Re: Border Winds Energy Project, Rolette County, North Dakota
Case No. PU-08-797

In the matter of the Siting Application of
Sequoia Energy US Inc. for the 150 MW Border
Winds Energy Project, Rolette County, North
Dakota

**PETITION FOR MODIFICATION OR
AMENDMENT OF FINDINGS OF FACT,
CONCLUSIONS OF LAW, AND ORDER
GRANTING CERTIFICATE OF SITE
COMPATIBILITY**

Border Winds Energy Project
Turbine Location Adjustments
Between Nov. 2011 and Oct. 2013*

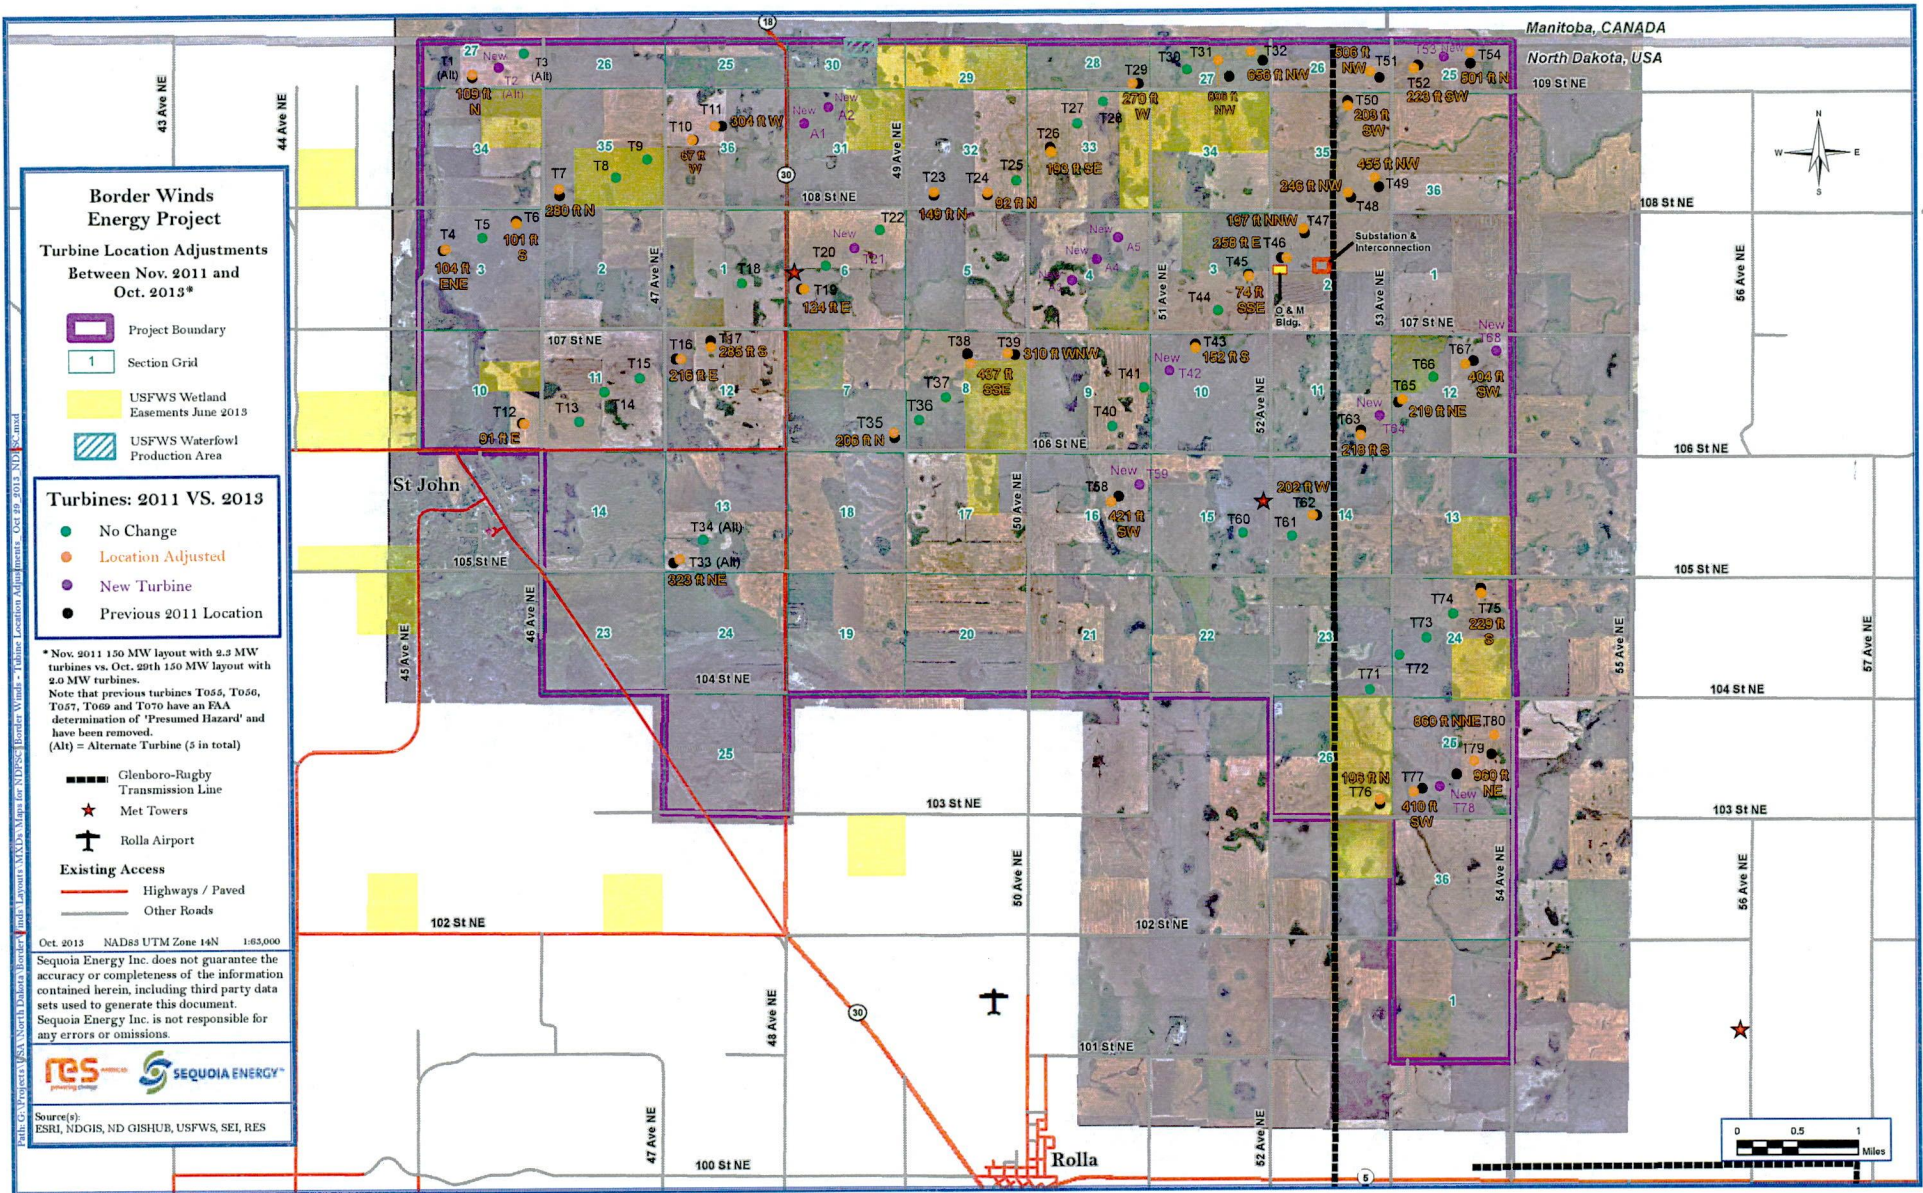
As specified in Paragraphs 1 and 8 of the Findings of Fact in the Order, the Project was to consist of up to sixty-six Siemens 2.3 MW wind turbines totaling approximately 150 MW of generating capacity, and each such turbine was to have an 80 meter (262.5 foot) hub height and a 101 meter (331.4 foot) rotor diameter. Border Winds Energy has now identified a different wind turbine generator for the Project: the Vestas V100 2.0 MW wind turbine generator on 95 meter (311.7 foot) towers with a rotor diameter of 100 meter (328.1 feet). The Vestas V100 begins operations at wind speeds of 3 meters per second and reach a rated capacity of 2.0 MW at 16 meters per second. To maintain appropriate turbine spacing and other setbacks, this change in the wind turbine generator also requires revision to the turbine layout. The revised turbine layout is included as Attachment 1.

*Nov. 2011 150 MW layout with 2.5 MW turbines vs. Oct. 2013 150 MW layout with 2.0 MW turbines.
 Note that previous turbines T056, T056, T057, T069 and T070 have an FAA determination of "Presumed Hazard" and have been removed.
 (Alt) = Alternate Turbine (5 in total)
